**WARRANTY
BULLETIN**

WB13-49

DATE :	JULY 2013	SECTION :	04 - Exhaust
EXPIRATION:	JULY 2015		
SUBJECT :	UREA QUALITY SENSOR 21891229 REPLACEMENT

On the vehicles affected by this bulletin, replace the prototype version of the Urea Quality Sensor #21891229 by the production version of the sensor #22073036.

Figure 1 : UQS 22073036 Pin-out

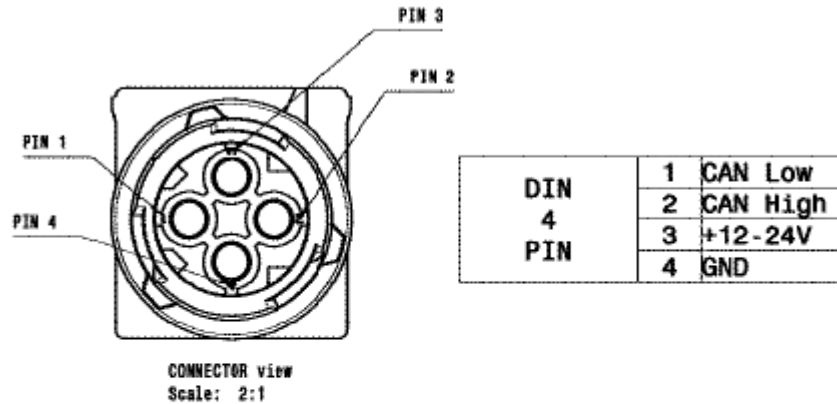
3. Modify connector pin out according to FIGURE 2.
4. *Protect with a plastic bag to avoid any DEF contamination.*
